Hastings District Council

COMMISSIONER HEARING

ITEM	SUBJECT	PAGE
2.	IONA URBAN DEVELOPMENT AREA - VARIATION 4 TO THE PROPOSED HASTINGS DISTRICT PLAN	
	<u>Document 4</u> Containing these attachments	
	Attachment BQ Urban Design and Landscape Design Statement - Final	Pg 1
	Attachment BR Traffic and Roading Submission Analysis (Stantec)	Pg 15
	Attachment BS Stormwater Submission Analysis and Assessments	Pg 23

To: Anna Sanders
From: Matthew Kneebone
Copy to: Rowan Wallis
Date: 14 May 2018
Subject: Iona-Middle Housing Development – Response to Stormwater Submissions

Figure 2 - Proposed mitigation option for Outlet E Catchment

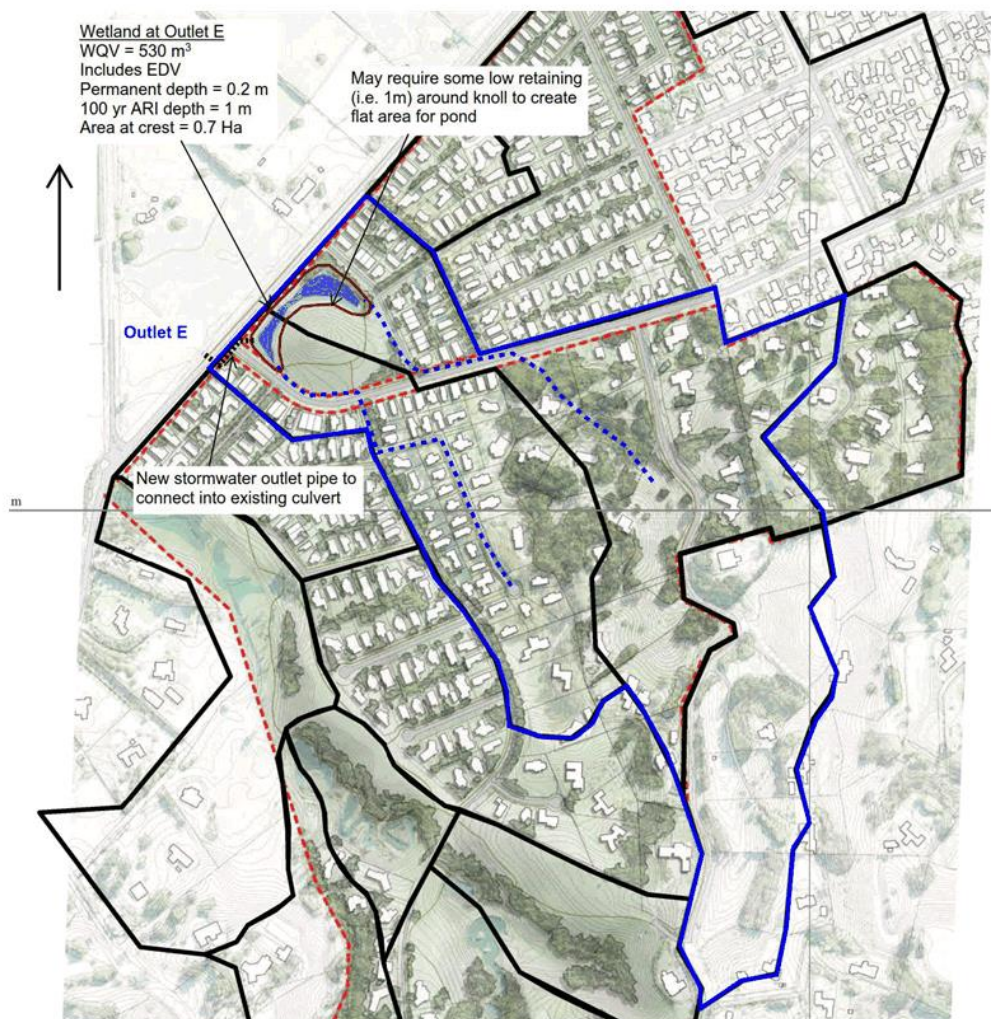
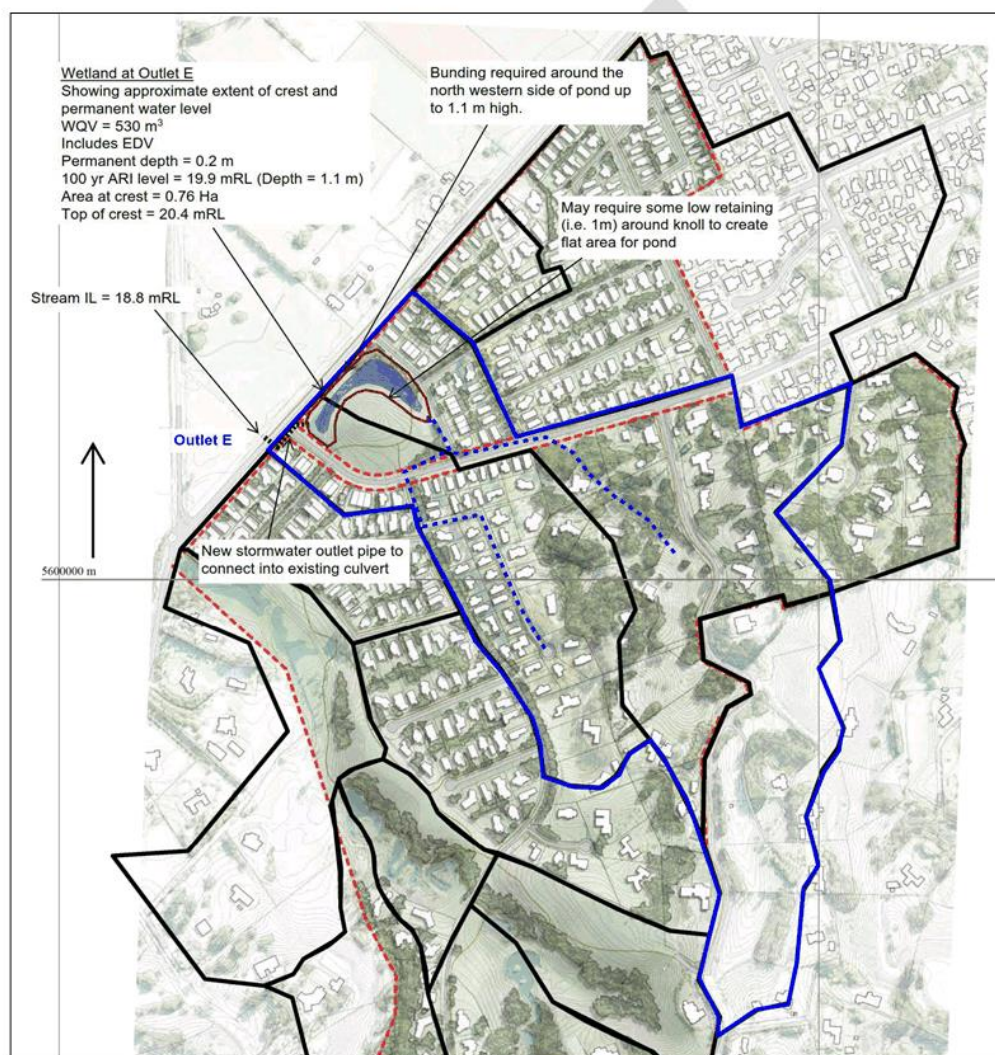
1. Stormwater management with a particular focus on Outlets D, E, F & I.
2. Historic ponding issues on site, creation of land drainage across property. Wants piping of open drainage network through their property.
3. Concerned the structure plan does not include drainage improvements on the Davidson land.
4. No increase in the catchment area draining to Outlet E.
5. No flooding to occur on land in the future.

Outlet E: This outlet is located at the base of the Bull Hill and discharges under Middle Rd into the Davidson land. A storage pond will be created at the base of the Bull Hill to provide mitigation of post-development flows and the post-development catchment will reduce by 3 hectares.

4. The developer is proposing to reduce the size of the catchment draining to Outlet E and also provide a storage pond for mitigation of post development runoff.

Outlet E/Bull Hill: A storage pond similar to that proposed at Outlet G is to be formed around the lower lying land of the Bull Hill reserve area. This storage pond will store and slowly release runoff via Outlet E. The existing land above Outlet E will be modified and will result in a decrease in the catchment area draining to Outlet E. The catchment area will reduce by 4 hectares, from 36 to 32 hectares. The effect of this area reduce and the mitigation proposed will reduce the peak flow rates discharging into Outlet E.
